**Design Review Committee  
April 10, 2014**

**TO:** Chair and Members of Design Review Committee

**SUBJECT:** **Case 19156: Substantive Site Plan Approval – Mixed-Use Development, 5262 & 5268 Sackville Street and 1593 Market Street, Halifax**

**Elevations**

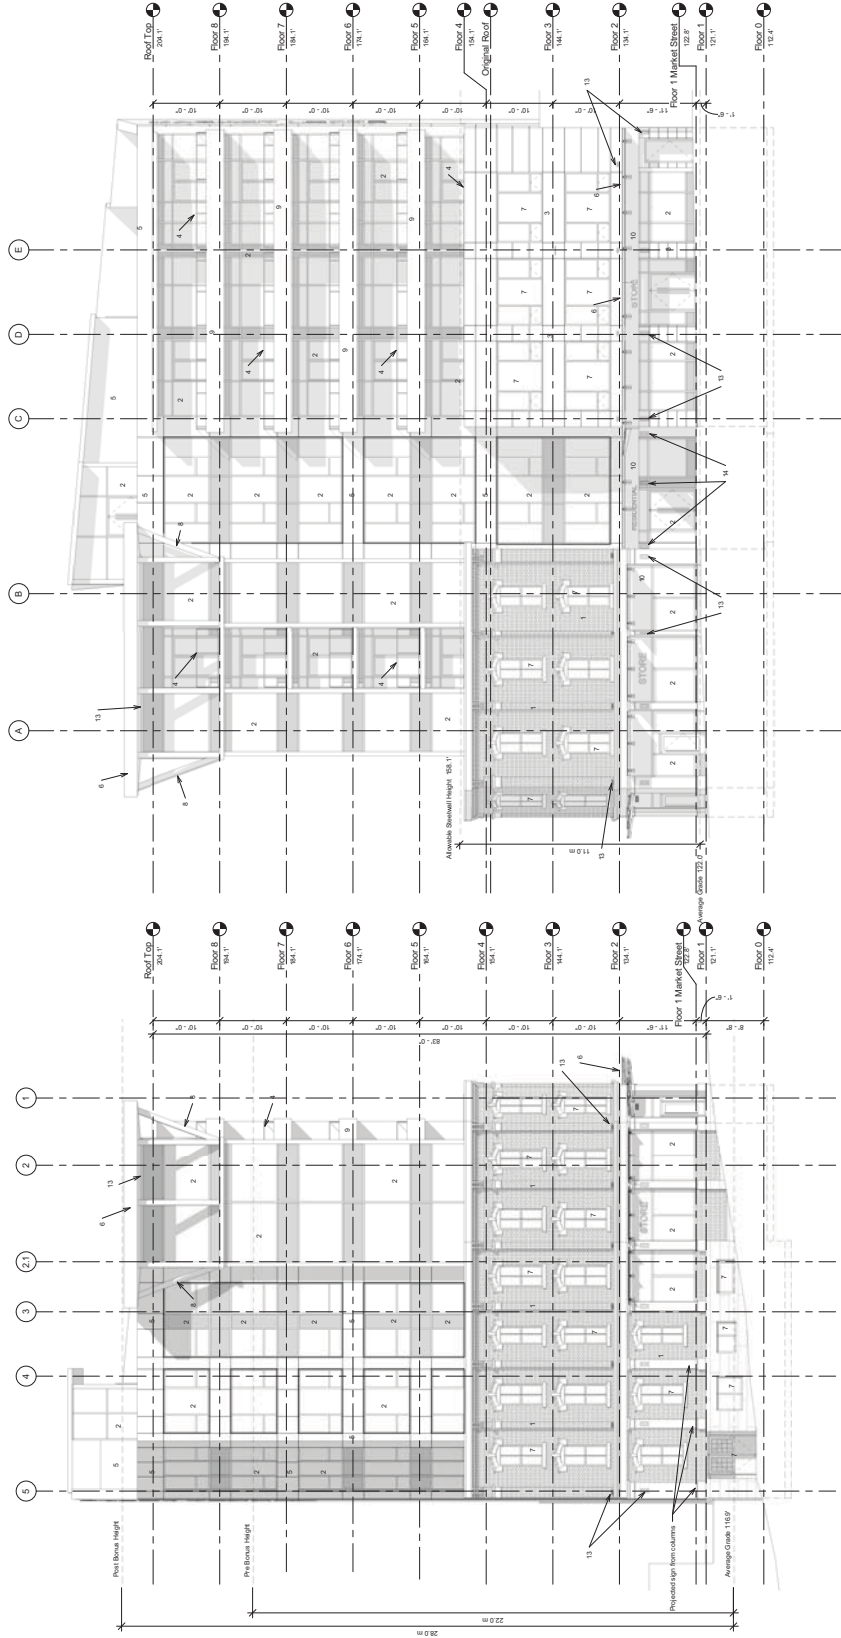
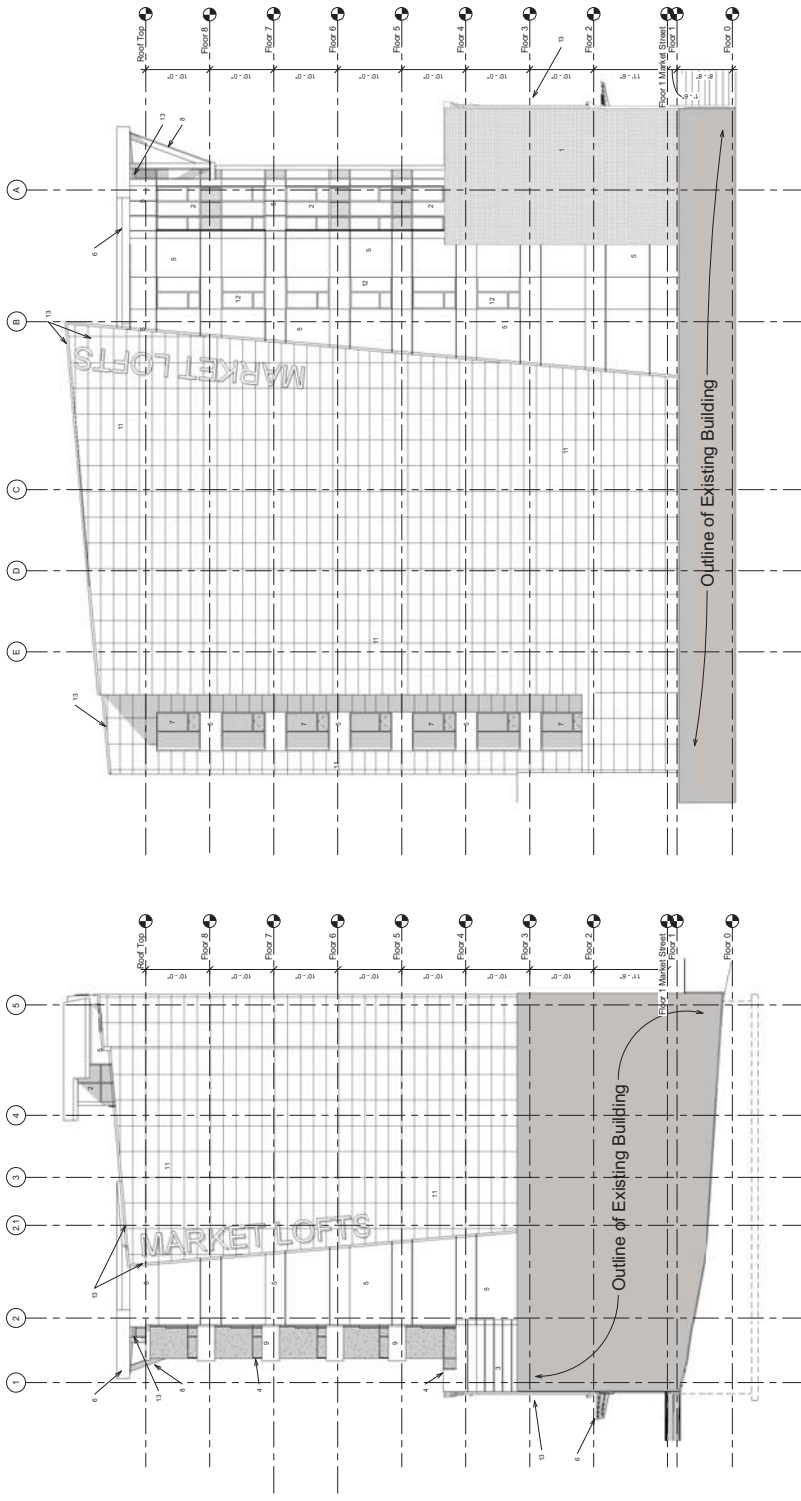
Under the Design Manual, streetwalls should be designed with the highest possible materials and to provide architectural variety and interest. The proposed addition along Market Street is designed in a more modern, yet basic, design comprised mainly of granite panels. In comparison to the richer architectural detailing on the brick and masonry façade to be retained, the addition appears to be more subdued. This was intended by the architect in order to create greater emphasis on the retained façade.

Although more subdued when compared to the existing façade, the proposed addition is to be developed of granite panels which is considered a form of high quality design material and includes large windows to break up the massing of the building. Staff are of the opinion that the proposed addition successfully meets the street wall design criteria of the Design Manual while keeping the main focus on the existing façade.

application. However, the elevations show proposed commercial signage in a band above the store front windows and appears to be in keeping with intent of the Design Manual.

*Non-Compliance:* The proposed street wall of the new addition along Market Street is approximately 10.5 metres.

*Response:* The proposed streetwall of the new addition along Market street is to match the streetwall height of the façade of the existing building at the corner which is to be retained, which will provide consistency for the building. It is therefore recommended that the DRC grant the requested variance.

*Non-Compliance:* The proposed upper storey setback at the corner of the building is approximately 2.4 metres.

*Response:* The majority of the upper storey has the required stepback of 3 metres. The stepback at the corner is reduced to bring visual prominence to the corner which is in keeping with objectives and guidelines of the design manual. Further, the reduction in the stepback helps tie the roof top architectural feature to the base of the building and provides an overall positive benefit to the design of the building. It is therefore recommended that the DRC grant the requested variance.
